December 1, 2017

**Re: Response to WDNR Questions Regarding the Supplemental Site Investigation Report  
Former Hoffman's Valet Cleaners  
7215 W. Center Street  
Wauwatosa, Wisconsin 53210  
BRRTS# 02-41-307576  
FID# 241083150**

CITY UTILITY LAYOUT

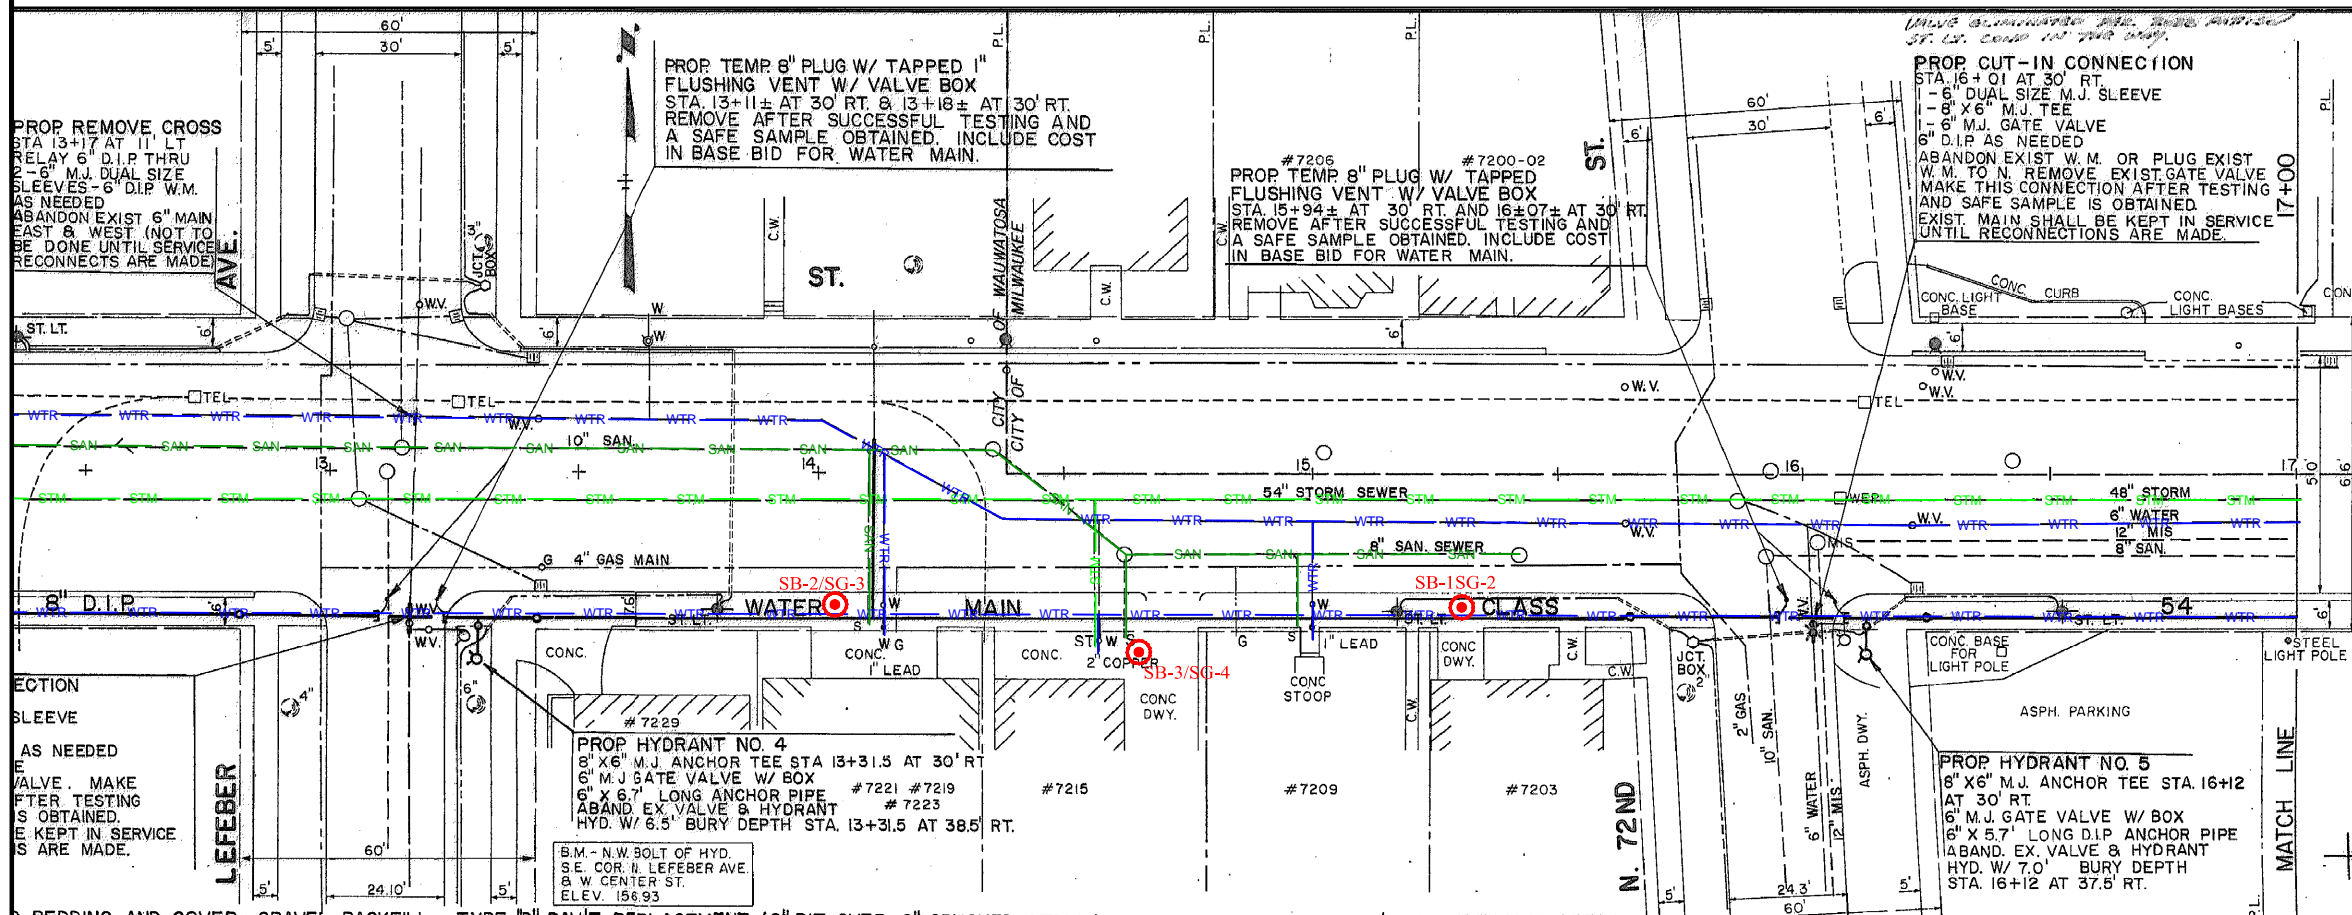
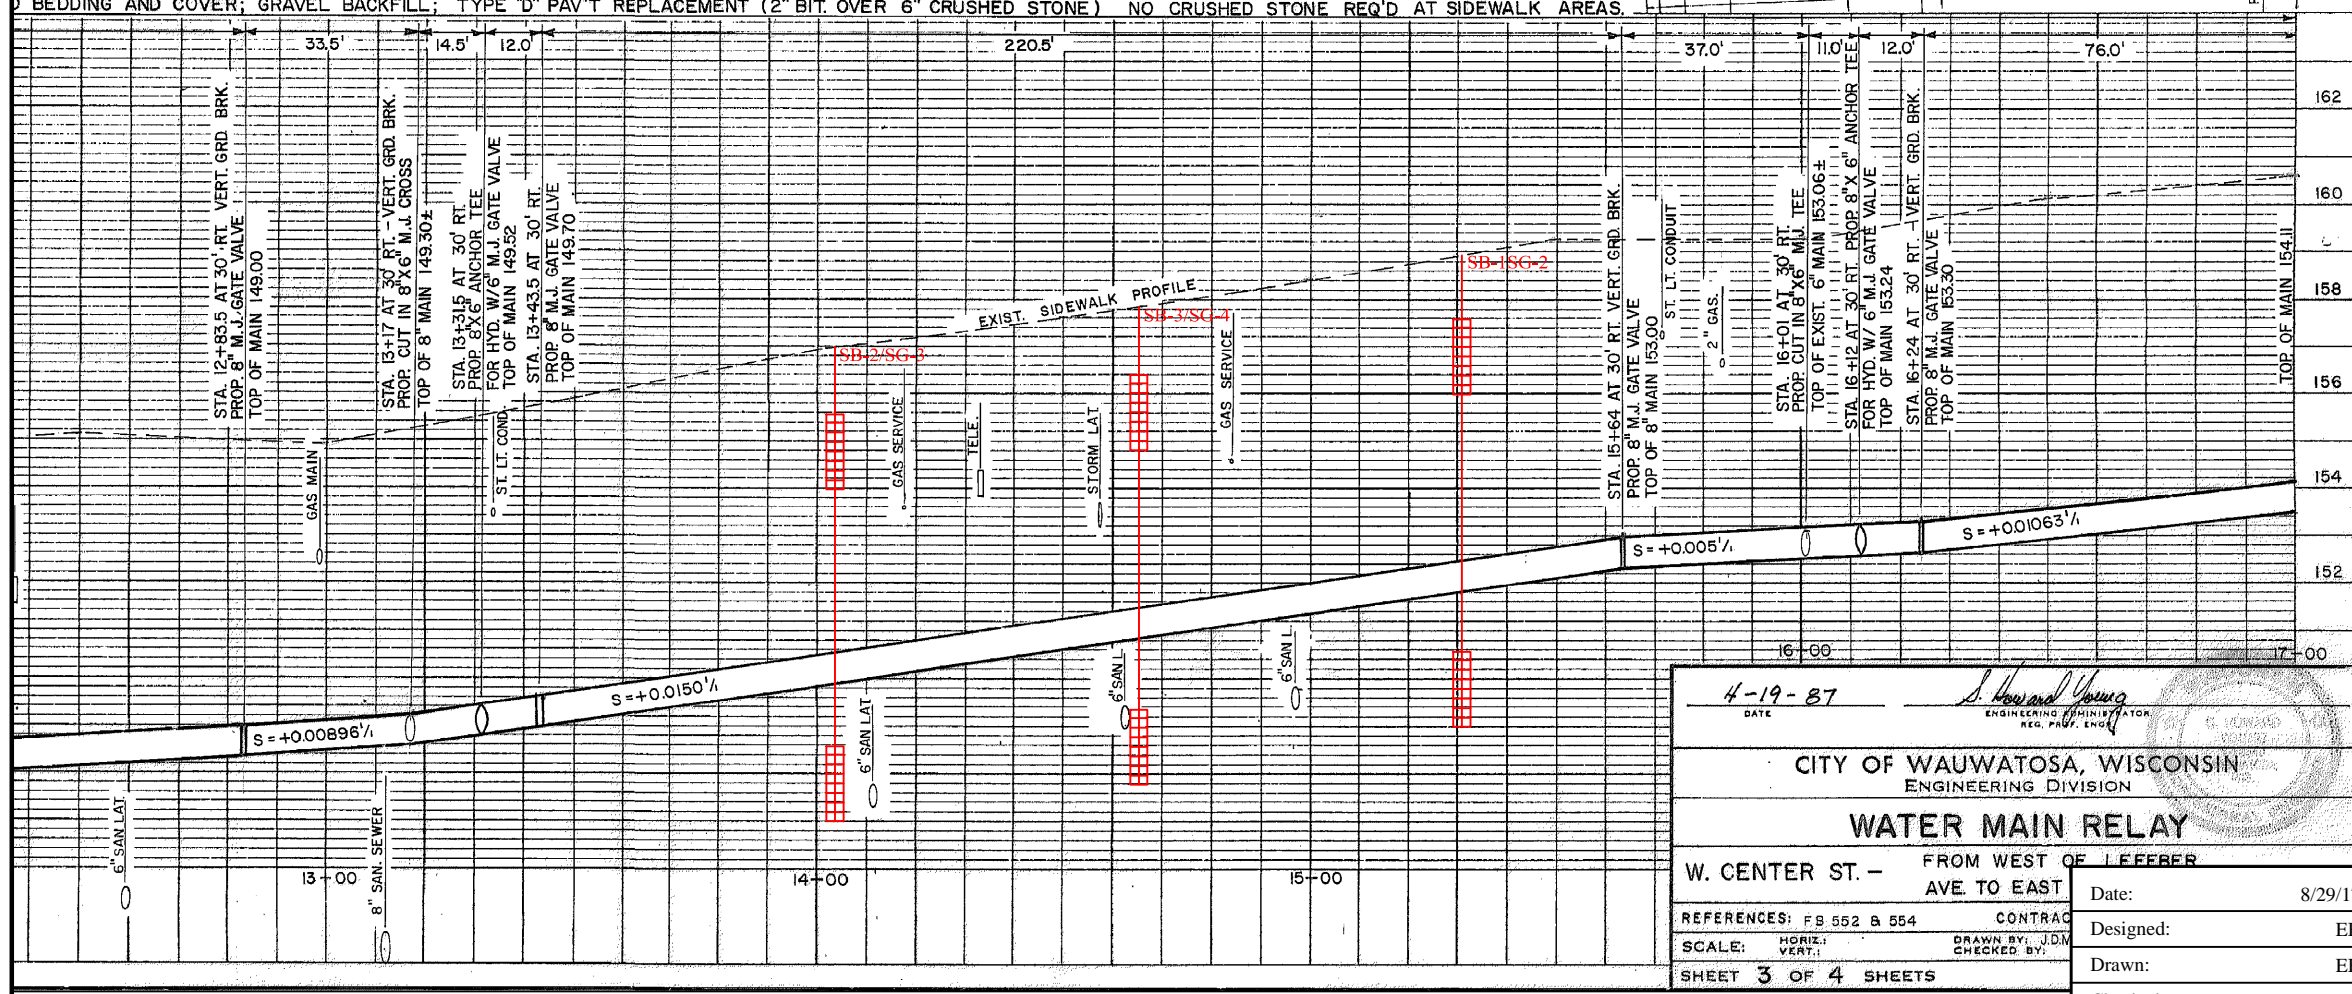
- a. **Discuss in more detail the results of the soil gas sampling in the right-of-way (ROW) relative to the depths of the utility lines. If there is a potential pathway for further migration along the utility lines, then assess the potential effect on offsite properties. This may result in additional vapor sampling.**

Vapor samples and soil samples were collected by EnviroForensics at the locations and depths shown on the utility drawing, **Figure 8**. The samples were collected from locations along the water service line extending east and west in front of neighboring properties. As can be seen on the soil boring logs previously provided for SB-1, SB-2, and SB-3, soil encountered was silty clay with the exception of a sand layer that was encountered in SB-1 at a depth of 9-10 feet bgs, which was the maximum depth of the boring. Vapor sampling points having a 6-inch long screen were set in sand filter pack from 8-10 feet bgs. The remaining upper eight feet of borehole was sealed with bentonite. This would have put the sample interval within one foot of the water main invert. SB-3/SG-4, was located near the water main, and also in close proximity to the sanitary lateral entering the building. As seen on **Figure 8**, high concentrations of PCE were detected in soil and vapor at this location. However, soil and vapor concentrations were very low at both SB-1 and SB-2. This indicates that the water main did not act as a conduit for vapor migration.

**CROSS SECTION  
A-A'**

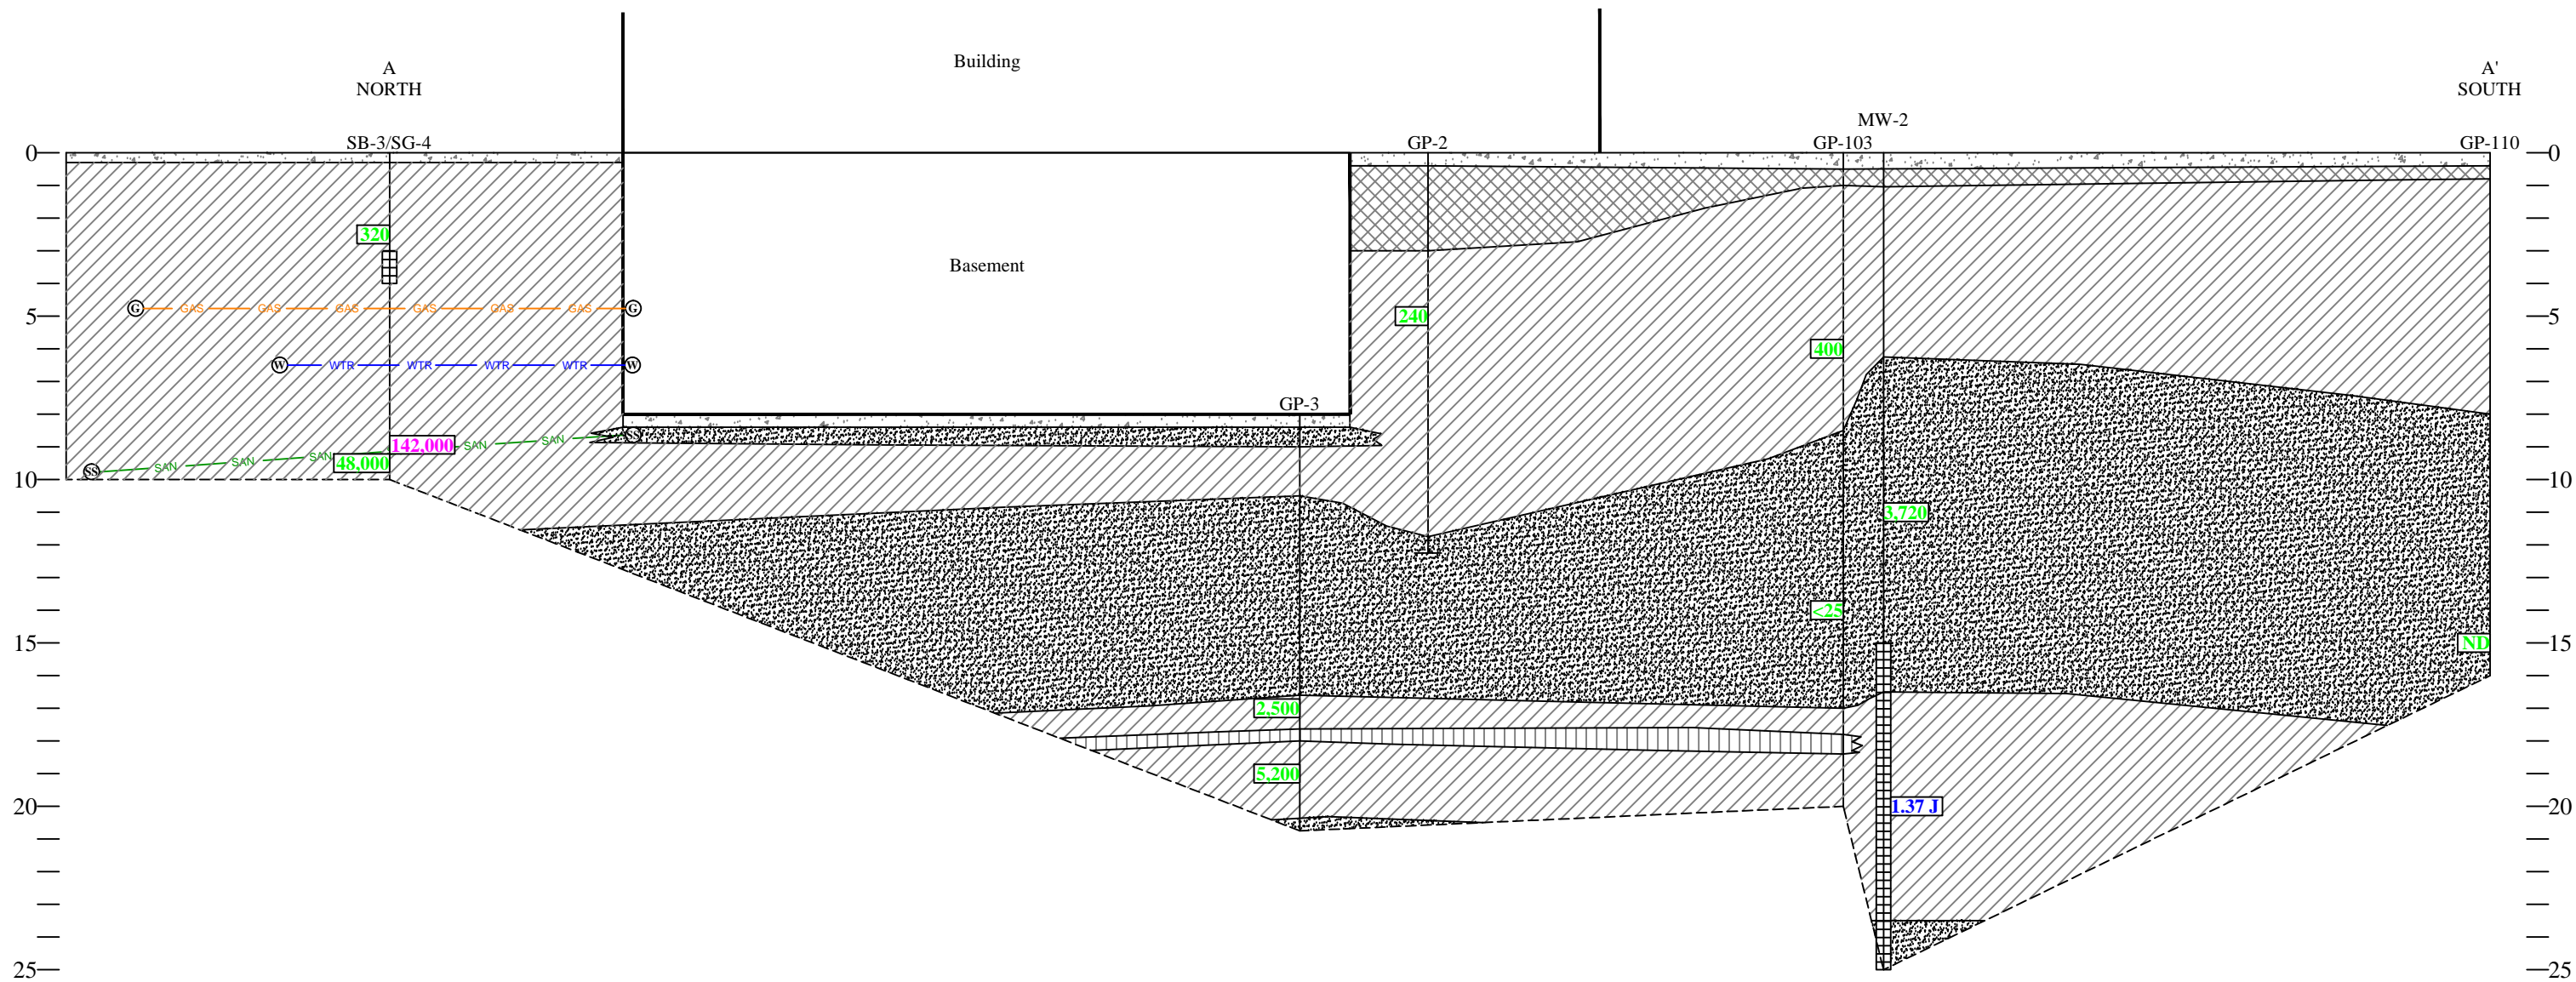
- a. The source area(s) aren't clearly defined. There appear to be source areas located at MW-2, GP-3, and SB-9/SG-4. Are these areas separate or connected by migration along**

New geologic cross-sections have been prepared by Enviroforensics (**Figures 9, 10, and 11** in **Attachment 1**) according to the transects presented on **Figure 2**. As can be seen on **Figure 9**, the sanitary lateral is buried within a sand lense. The sand lense is continuous laterally from MW-2 to MW-1, but appears to pinch out near MW-1. The sand layer may have acted as a conduit for contaminant diffusion laterally to the south. Being near the lateral, soil samples collected from the 10-12 foot depth in MW-1 have contained elevated concentrations of CVOC's. Impacts at the same depth have been detected at MW-2, which is located to the south of MW-1. It is likely that contaminants have migrated laterally along the sand/clay interface which exists at a depth of approximately 12 feet.
